# Response to An Bord Pleanála Opinion

42A Parkgate St.  
Dublin 8

Mixed Use, Residential &  
Commercial Development  
ABP - SHD Application\_  
Project Ref: P18-107D

Block A Undercroft Bike Store

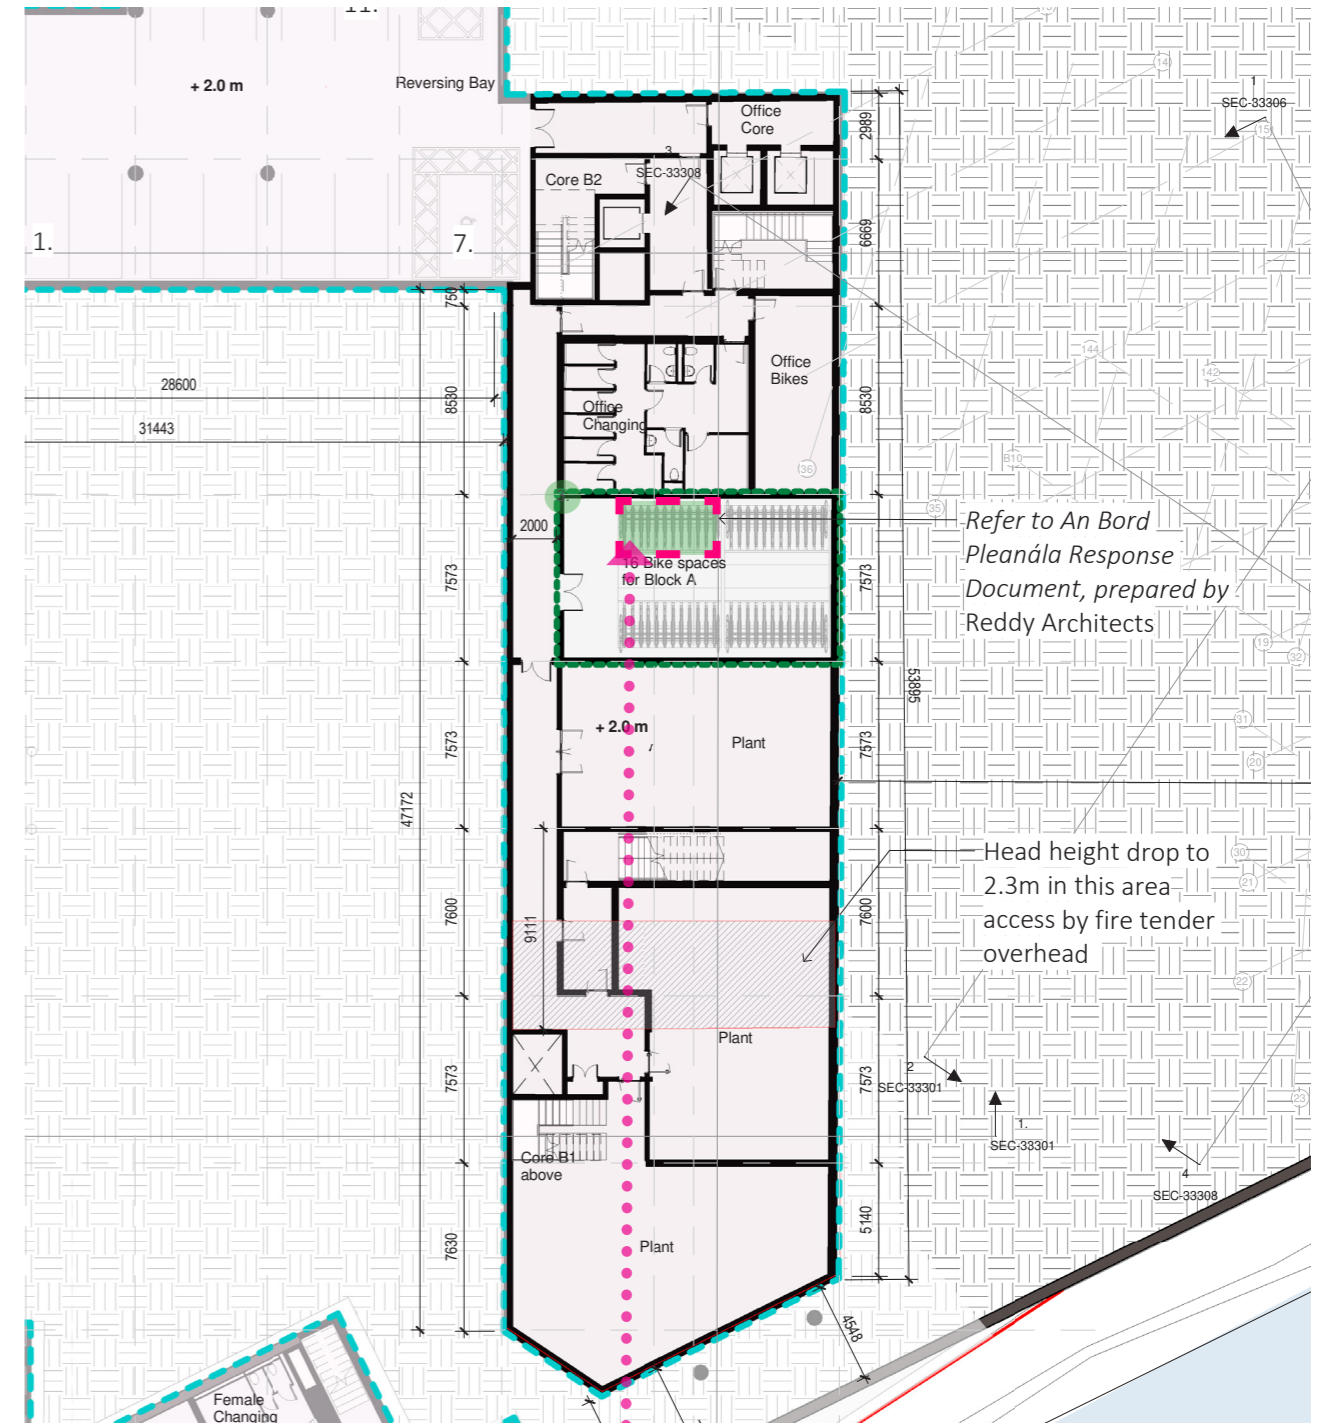
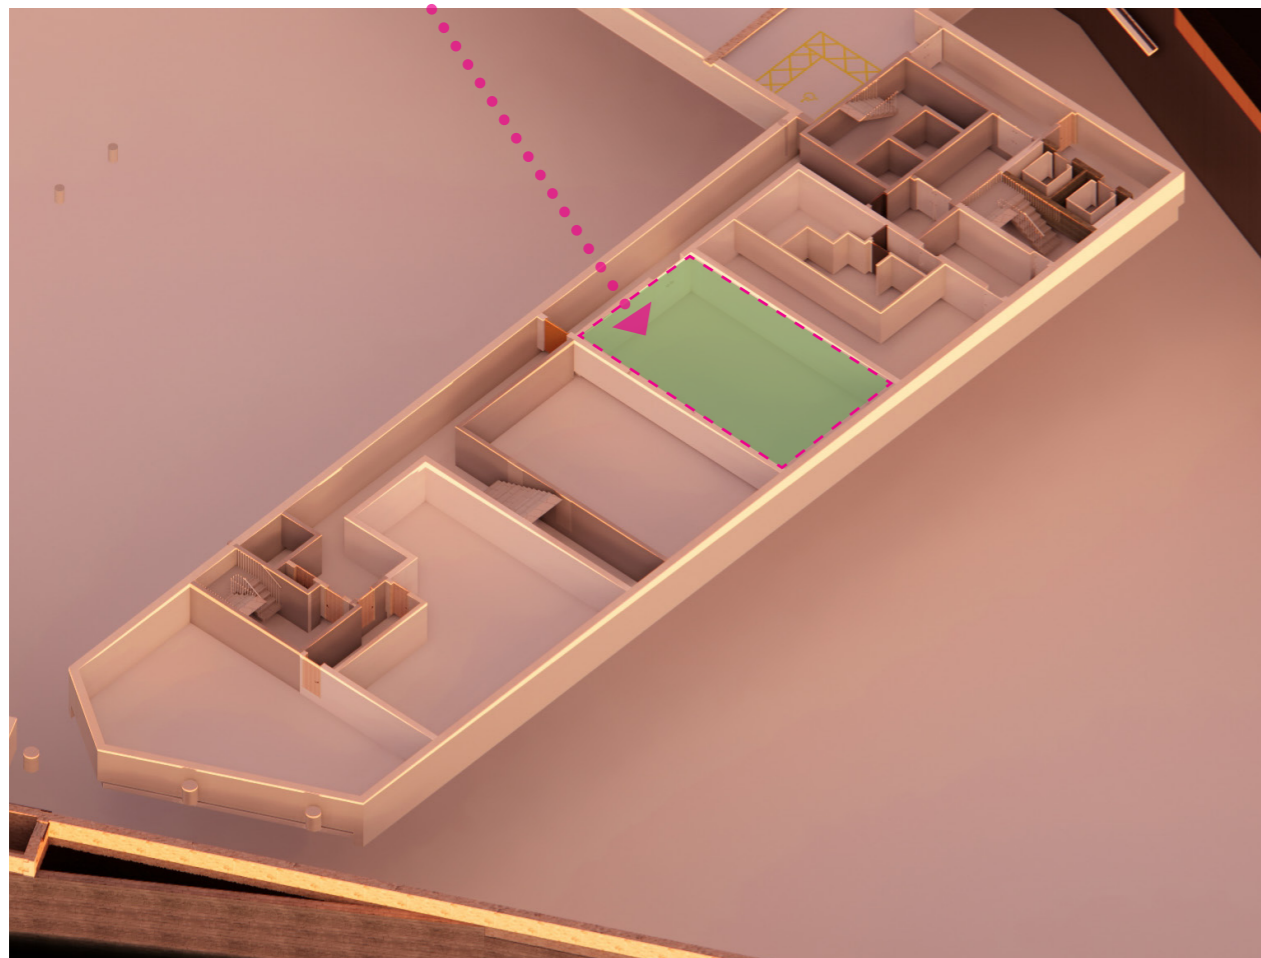
6. Additional cycle parking layouts should be clearly demonstrated and clarity provided on the overall provision and assignment of spaces. The provision of additional visitor cycle parking should be considered including cargo bike spaces.

16 Bike parking spaces for Block A

This has been addressed, please see attached diagram, the proposal is for 16 double stacked bicycle parking spaces in the Undercroft. Further information is available in the Housing Quality Assessment.

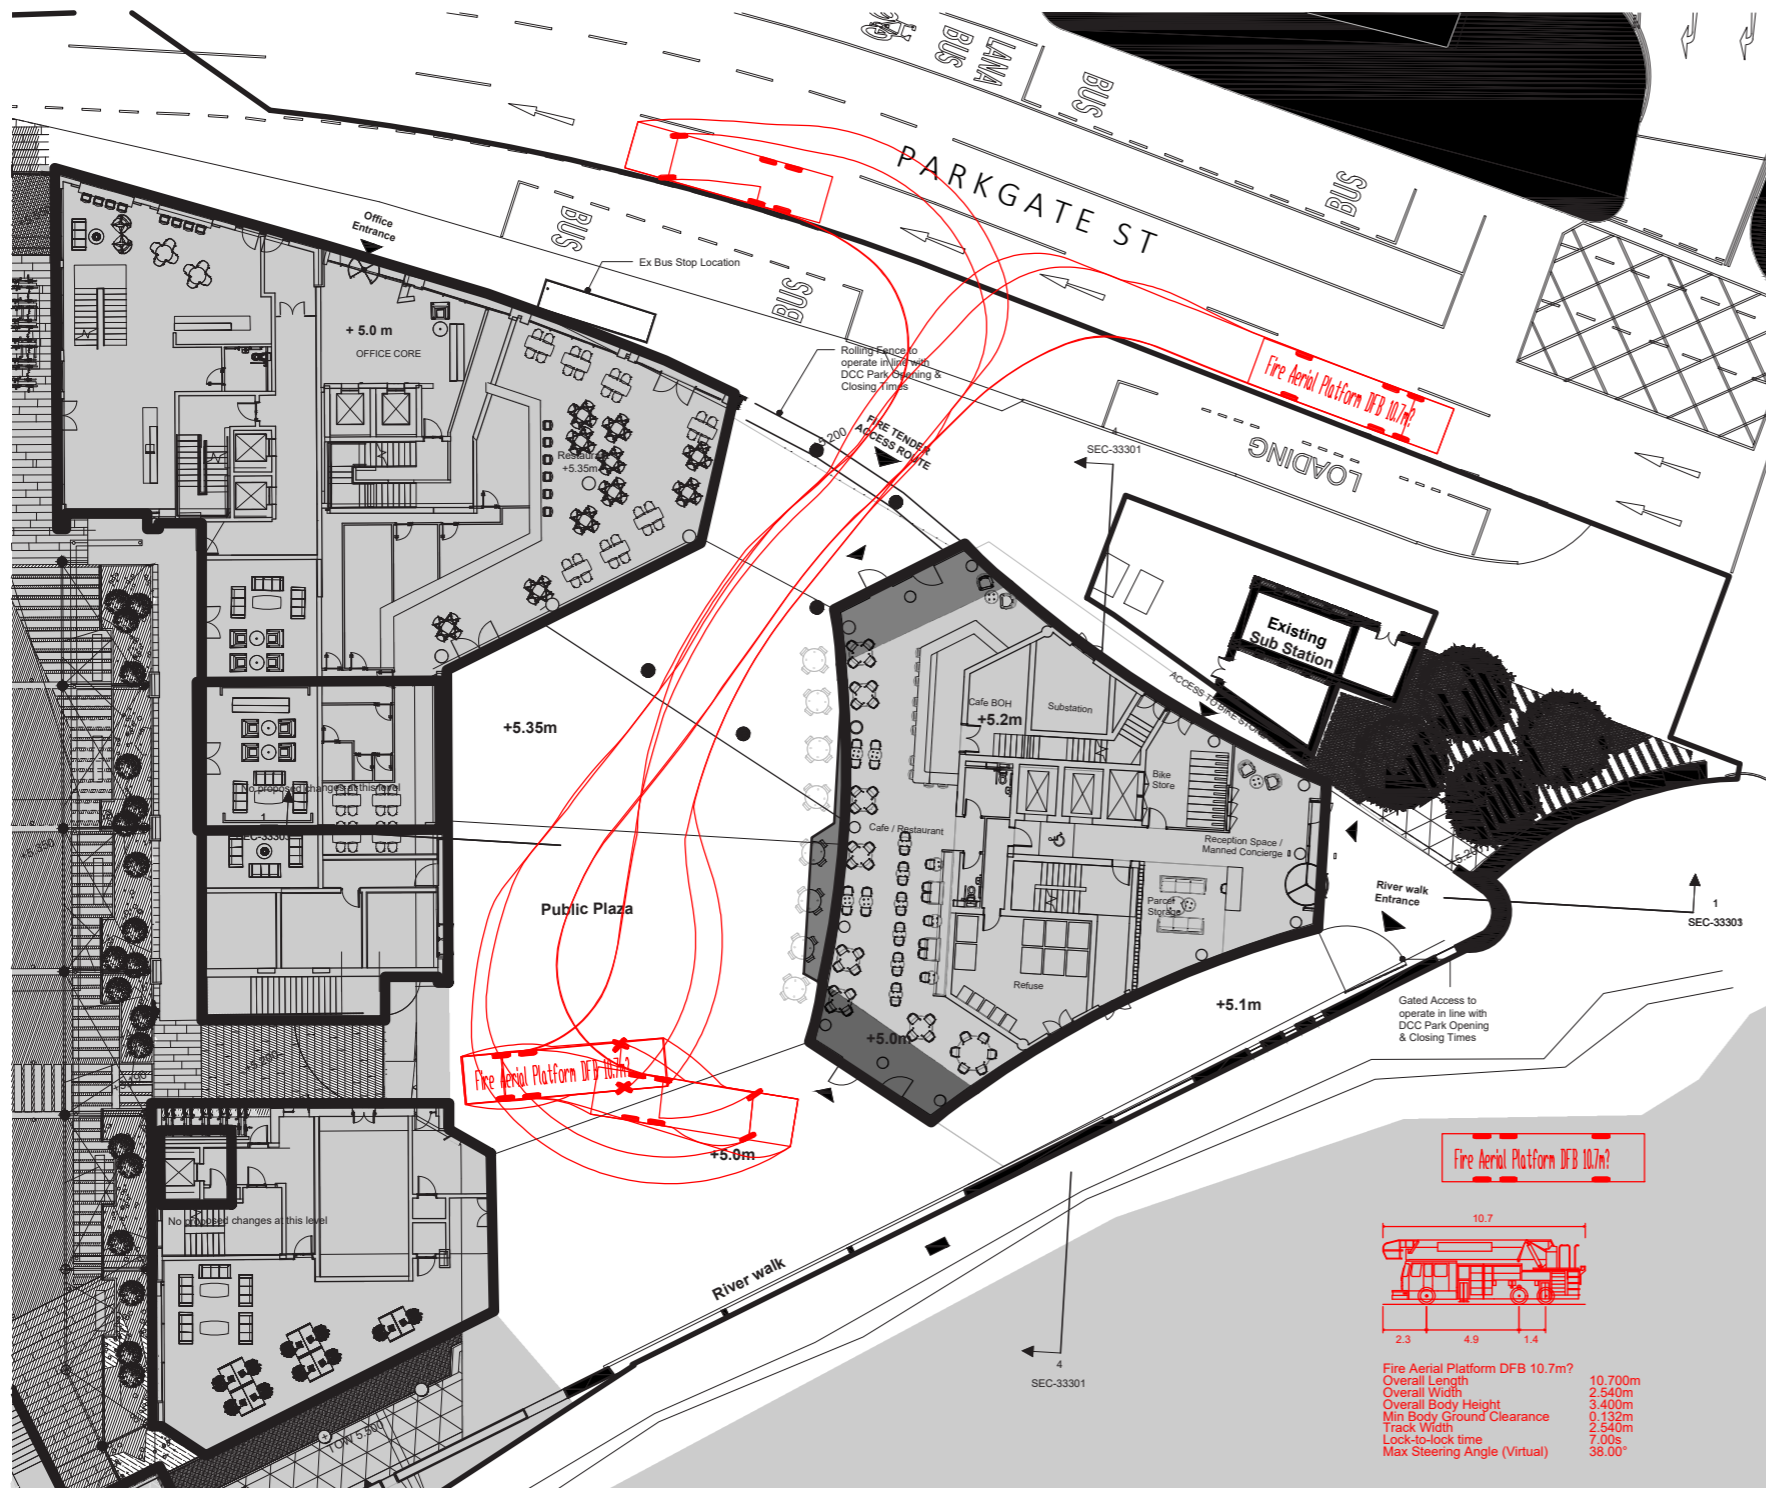
1. The proposed building line shall not extend into the public footpath, and the application drawings shall clearly demonstrate the interface between the proposed building line and the public realm. A drawing detailing topographical survey information overlain by proposed site layout shall be provided.

This has been addressed, please refer to the Architectural Drawings (Drawing Number PGATE-RAU-ZZ-ZZ-DR-A-MPL-31004)

Name  
TSK0012-001

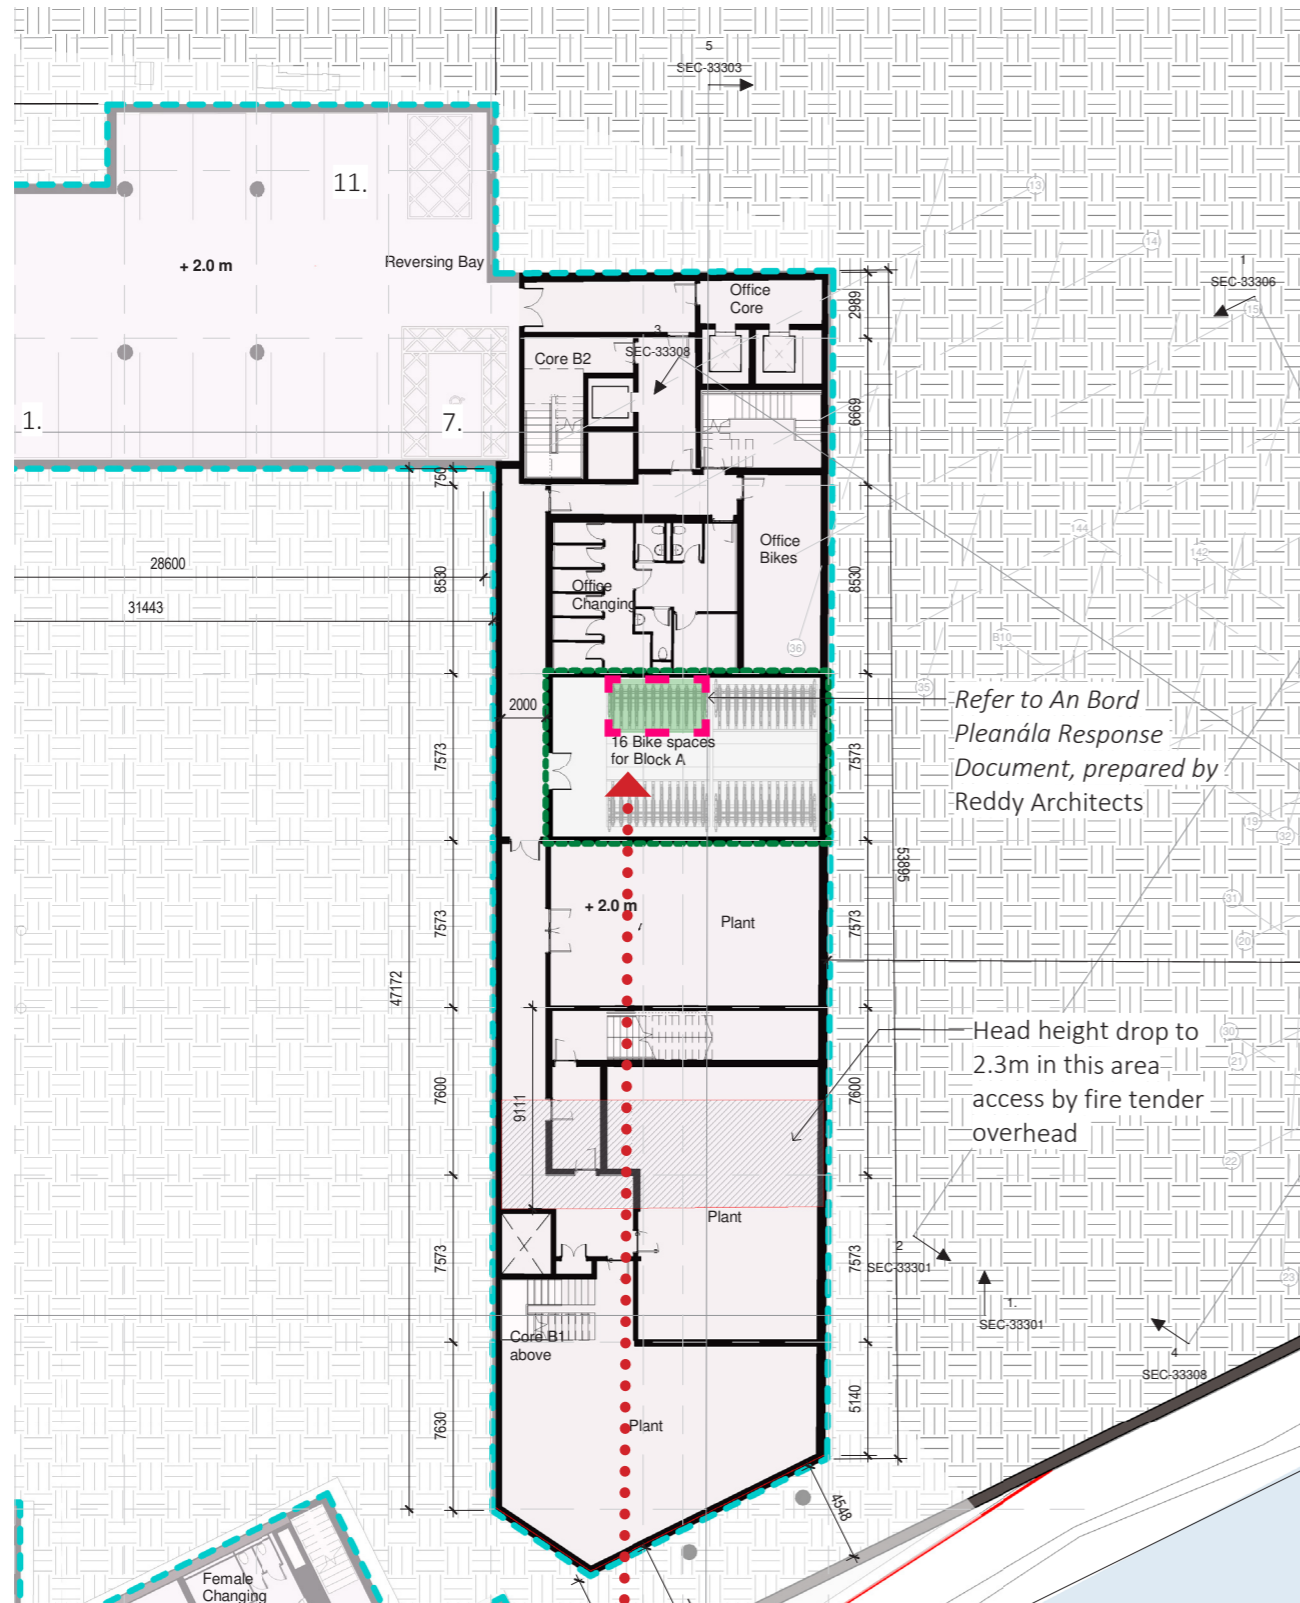
3. It is not clear from the proposed layout of Block A whether this reduces the access clearance for the public open space. Auto-track drawings are to be submitted if the proposed development impact on permitted vehicular access arrangements.

This has been addressed, please see Autotrack drawing attached (ARUP DRAWING TSK0012-001)
